MEMORANDUM

DATE: October 22, 2007

REVIEW TYPE: Site Plan Review
CASE #: 8200700160
PROJECT NAME: Baldwin Landing

APPLYING FOR: Six one-family detached residential dwelling units and 36 townhouse units, including six moderately priced dwelling units (MPDUs), on 4.03 acres.

Illustrative Site Plan³

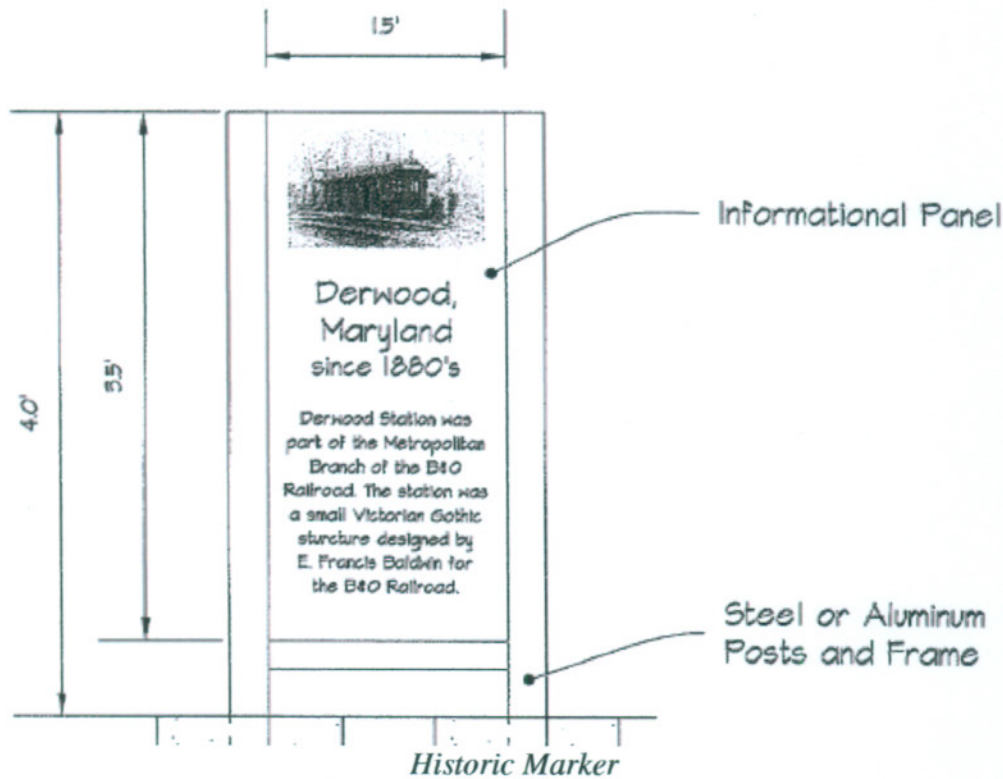
³ Not shown due to changes during the review period: the sidewalk on the eastern edge of Private Road A (Baldwin Station Way), the curb cut to the adjacent park, several handicapped ramps, and the sitting area between lots 19 and 20 (the sitting area on lot 13 has been removed). Private Road B is now called Mobiley Gift Lane.
